STAFF REPORT AMENDED 1-13-83
CITY PLANNING COMMISSION

- APPLICATION:
1. Environmental Determination
 2. Rezone 8± ac. from Single Family (R-1) to Townhouse (R-1A) (Sec. 2-13-3)
 3. Tentative Map (Subdiv. Ord. Ch. 40)
 4. Special Permit for zero-lot line development (Sec. 7-C)
 5. Variance to reduce the rear yard setback from 15 ft. to nine ft. (WITHDRAWN)

LOCATION: North side of Lemon Hill Road, 2000± ft. east of Stockton Boulevard

PROPOSAL: The applicant is requesting the necessary entitlements to divide 8± acres into 59 single family lots to be developed with a mixture of standard single family and zero lot line units.

TENTATIVE MAP
LEMON HILL ESTATES
 CITY OF SACRAMENTO
 DECEMBER, 1982

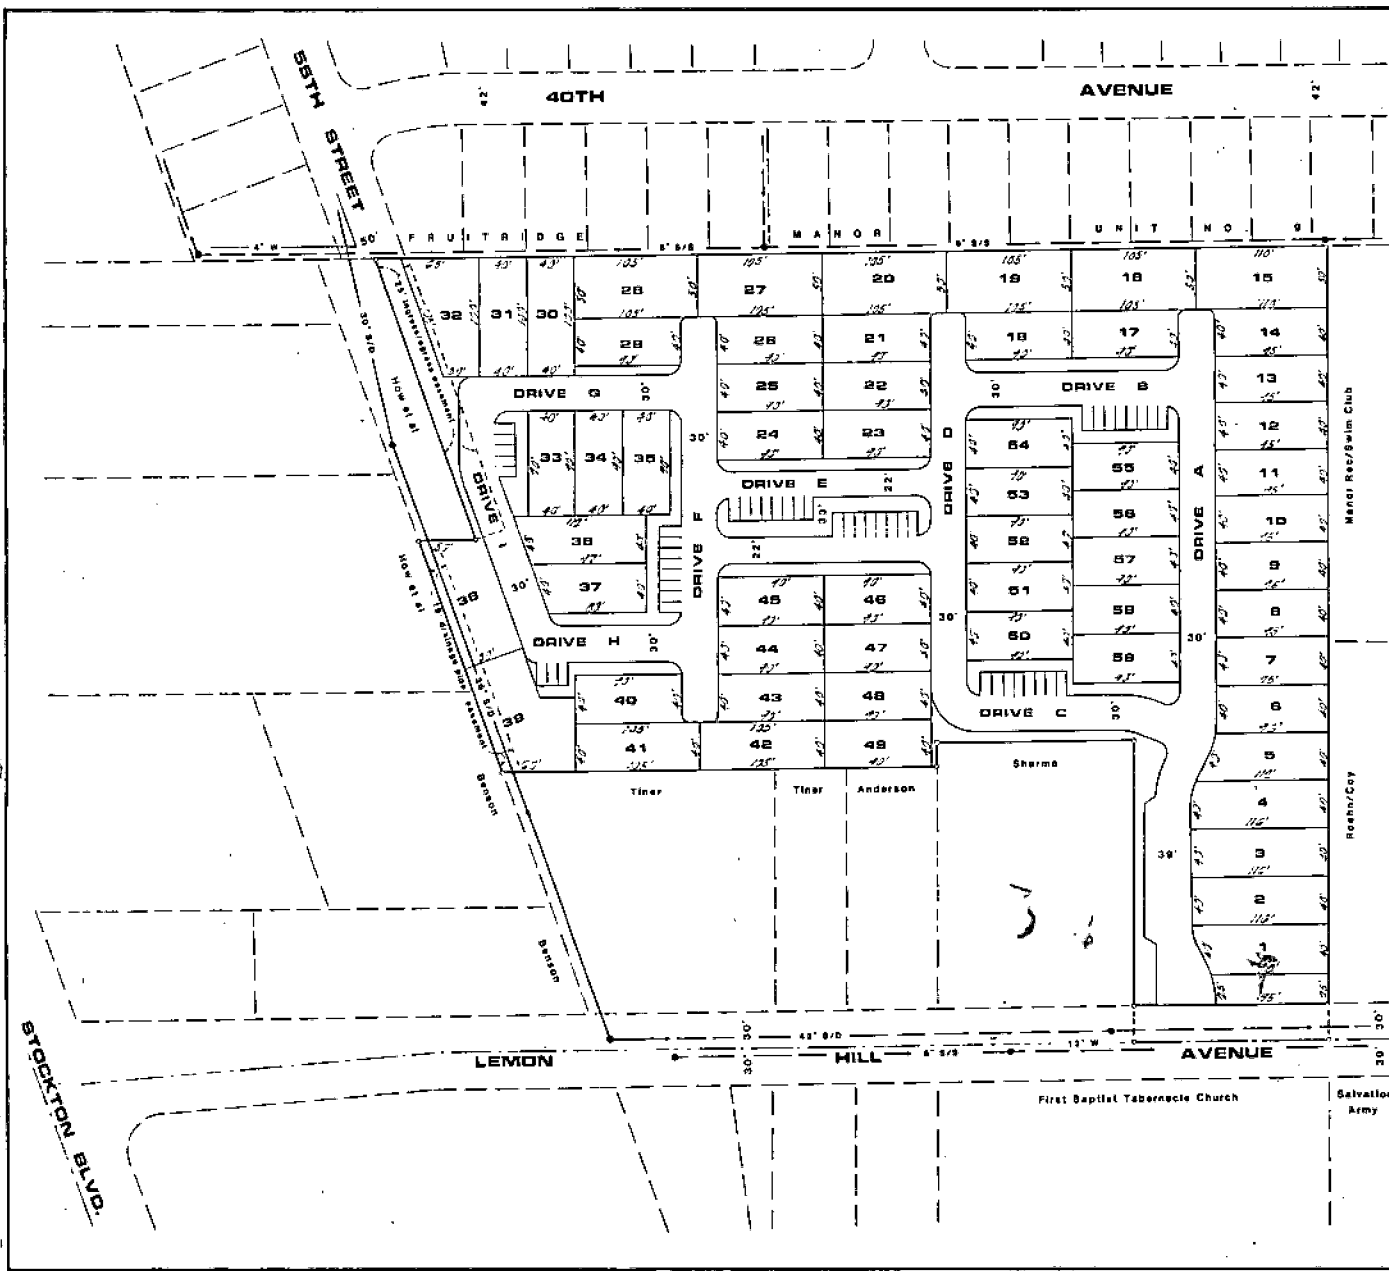
SUBDIVISION REVIEW COMMITTEE RECOMMENDATION: On December 22, 1982, by a vote of five ayes and four absent, the Subdivision Review Committee voted to recommend denial of the tentative map. Recommendations for denial were based upon inadequate access to service the site and the proposed stub termination of 55th Street.

1. Termination of 55th Street has been the major obstacle in the development of the subject site. The applicant proposes to stub 55th Street at the northern property line. An improved 20-foot wide emergency access easement is proposed to connect with the private interior street. This proposal is unacceptable to the City Engineer and the City Traffic Engineer. Both of these divisions have indicated support of the request if the applicant will provide a cul-de-sac to terminate 55th Street. Standard subdivision improvements are necessary for the cul-de-sac. Driveways from the cul-de-sac should serve the subject site and the adjacent commercial property. This cul-de-sac will necessitate a minor redesign of the tentative map.

- b. Provide a 40-foot radius cul-de-sac, improved to the satisfaction of the City Engineer and City Traffic Engineer, to terminate 55th Street. Will require off-site right-of-way dedication (City will condemn at the property owner's expense); (CPC amended to: ...cul-de-sac or such other design improved to...)

- f. Any amendments to the covenants, conditions and restrictions shall require the consent of the City;
- g. The applicant shall redesign the map to reflect: 1) the cul-de-sac to terminate 55th Street; 2) widen the entry roadway from Lemon Hill Avenue to 30 feet wide; (CPC amended to: 1) the cul-de-sac or other approved design that will terminate...)

lemmon hills WESTWOOD HOMES INC.
 sacramento, california

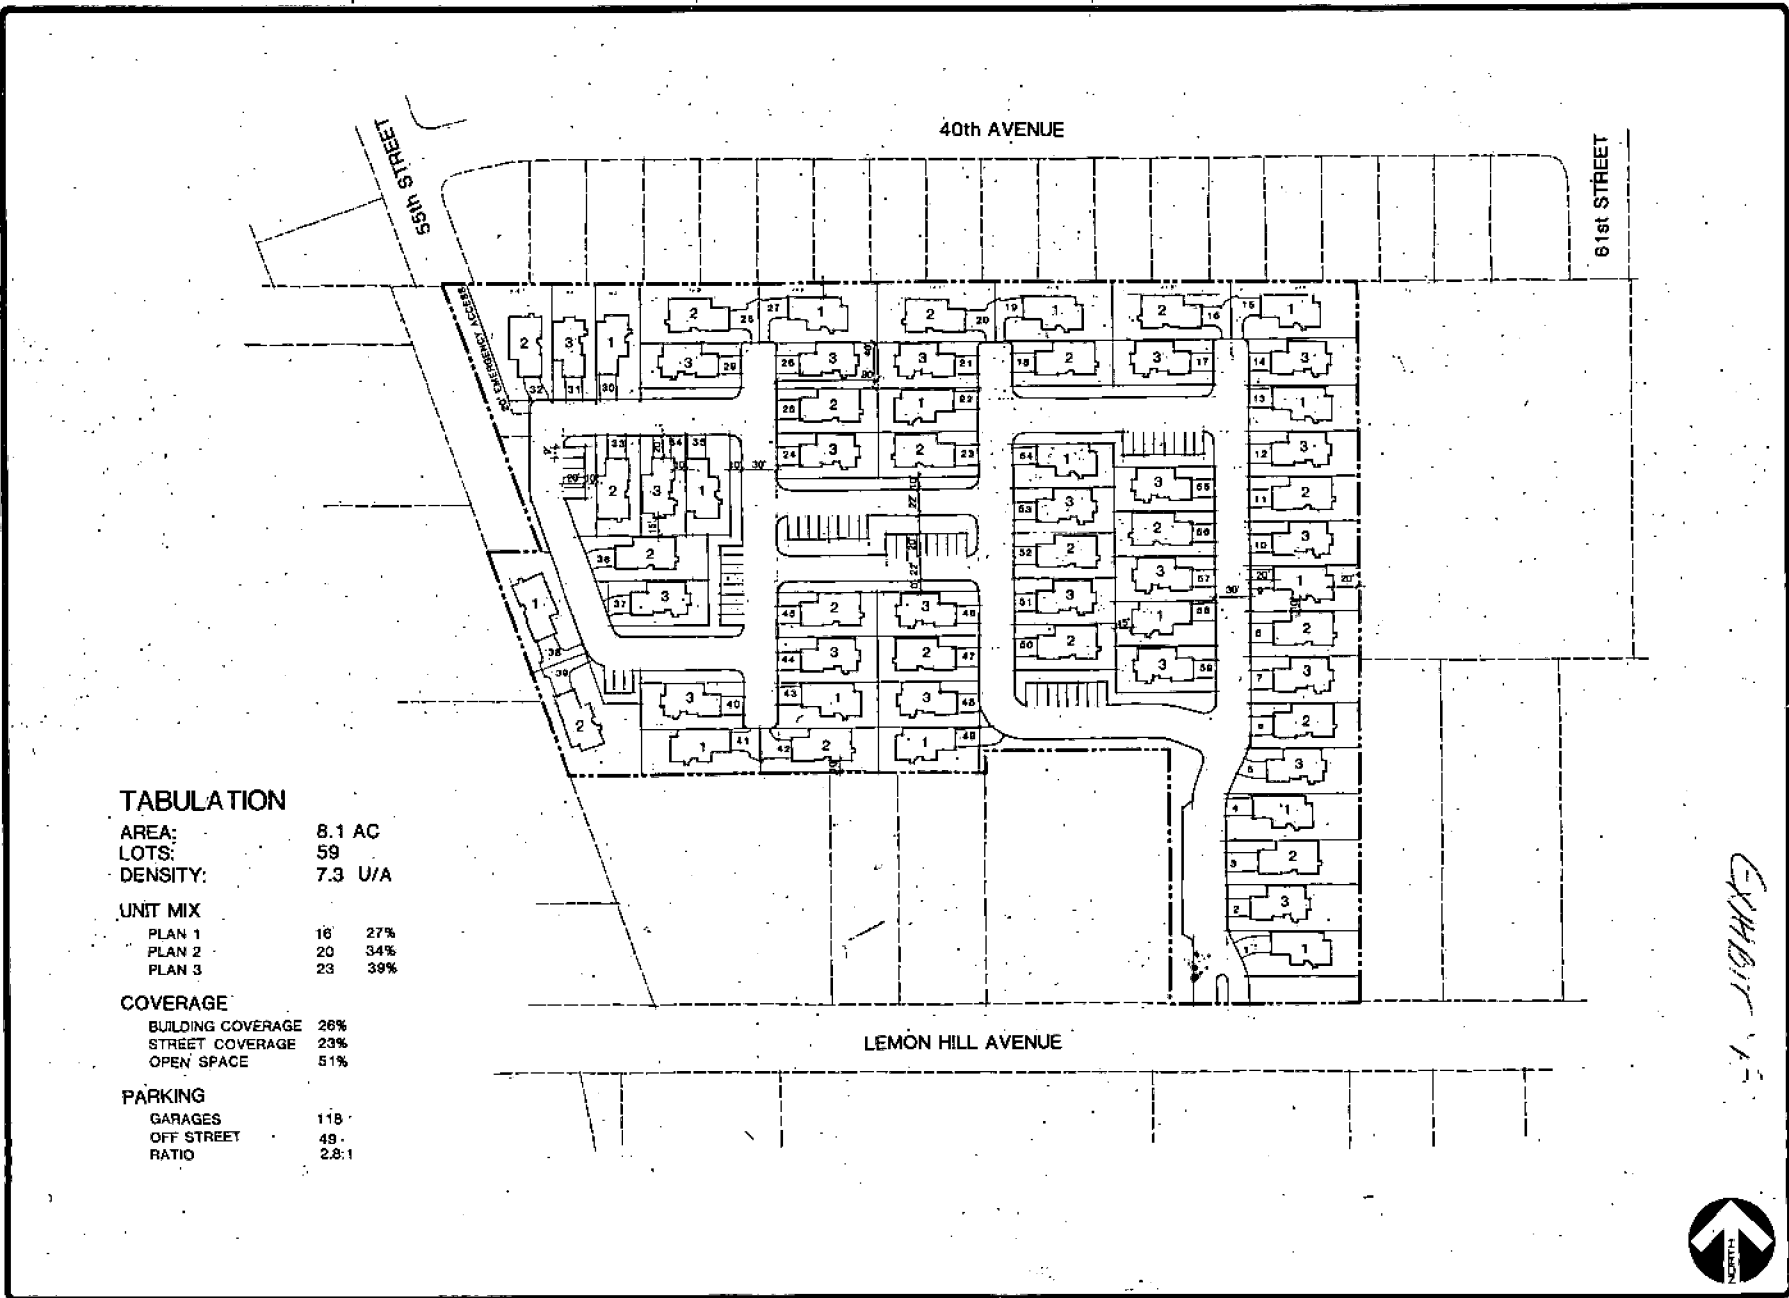
5. Only 70 percent of the units have adequate solar orientation. Shadowing caused by the two-story unit, No. 3, can be eliminated by shifting the structures on Lots 15, 16, 20, 27 and 28 to the north and obtaining a standard five-foot northern side yard setback (see Exhibit D). Units on lots 36 and 37 should be reversed (See Exhibit D). This will provide 80 percent of the units with adequate solar access.

7. Landscaping along the street side of the structures should be designed to soften the appearance of unbroken walls. Planting material should consist of one to five-gallon shrubs, five to 15 gallon trees and ground cover. Landscaping and shading plans will be subject to approval prior to issuance of building permits. Staff requests that the street be 30 feet wide along the entry road from Lemon Hill Avenue. This additional footage should be landscaped (See Exhibit D).

12. In order to buffer the proposed residences from the noise of adjacent commercial uses, staff requests a solid six-foot wall be erected along the west and south property lines abutting commercial uses. (See Exhibit D.)

- d. The site plan shall indicate a unit 2 located on Lot 37 and a unit 3 on Lot 36;
- e. The applicant shall construct a six-foot high wall of masonry or similar material along the property line adjacent to commercial uses or zoning. Design of the wall shall be approved by the Planning Director prior to issuance of building permits;
- f. Landscaping, irrigation and shading plans shall be subject to review and approval by the Planning Director prior to issuance of building permits. The landscaping shall consist of a variety of planting material that includes one to five-gallon shrubs, five to 15 gallon trees and ground cover.

EXHIBIT 'C'

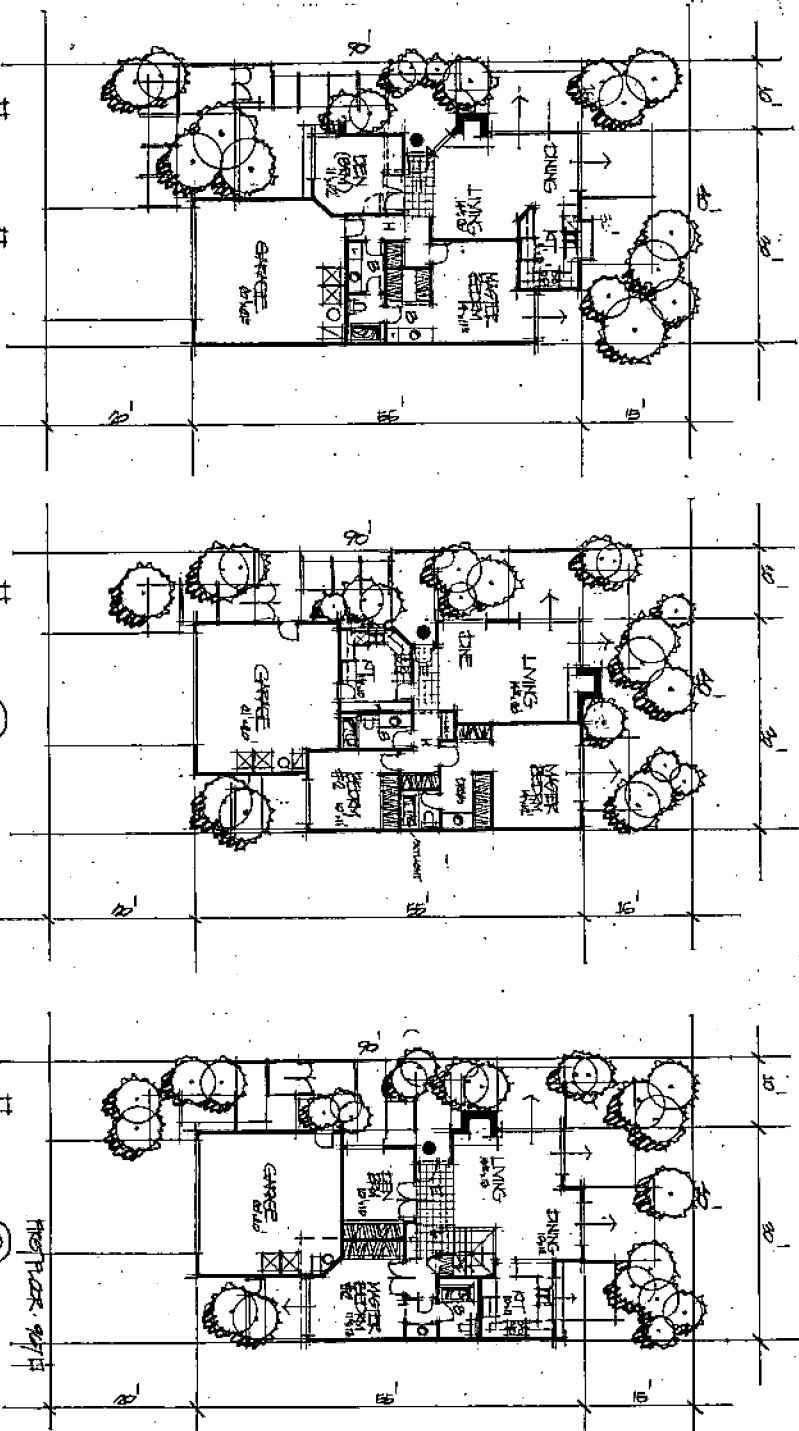
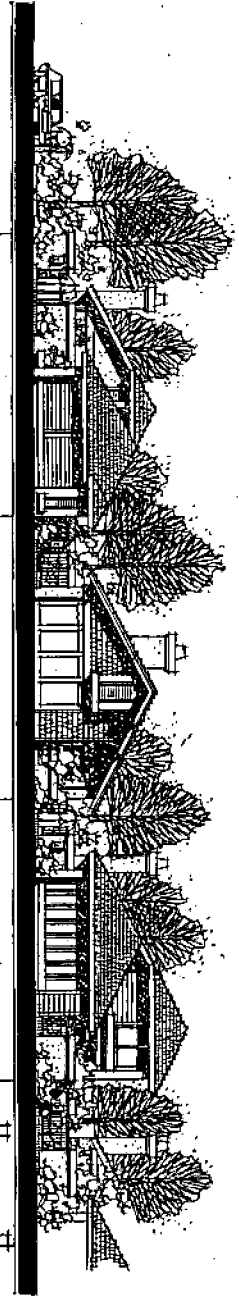
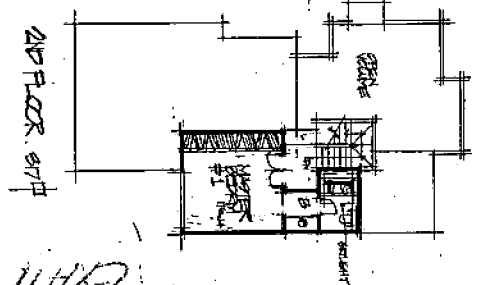
4. Only three exterior elevations are provided. Ordinarily staff would recommend additional elevations. However, the applicant is attempting to avoid a cluttered appearance by the use of many elevations. A varied and interesting streetscape will be achieved by emphasizing heavily landscaped front yards, various courtyard treatments and carefully selected colors, textures and materials.
